**Products:** CAM520 Pro

**Firmware Version:** 0.0.1004.36

**Published Date:** October 26, 2020

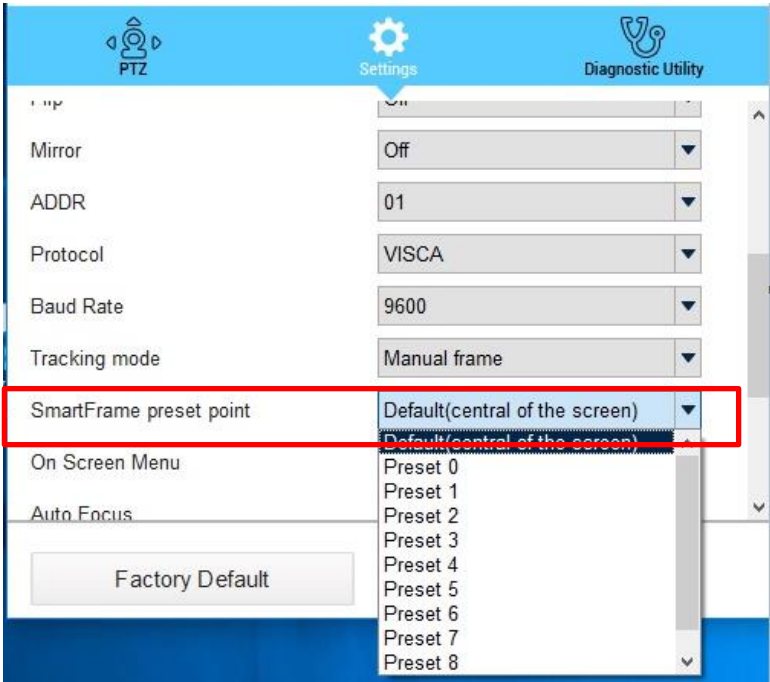
0.0.1004.18	1. Add SmartFrame preset point function. Original: Camera always goes back to central position to capture all participants and zoom in. New: Users can choose the preferred preset point direction and camera will capture all participants based on the appointed preset point <div data-bbox="475 1086 1248 1765" data-label="Image">  </div> <p>PTZApp should be upgraded to <b>v. 1.4.1087.90 (MAC)</b>; <b>v. 1.4.1112.116 (Windows)</b> to get full functions</p> 2. IP webpage: H.264 Profile setting adds two options: H.264 Baseline Profile/ High profile 3. VISCA command adds power on/ off
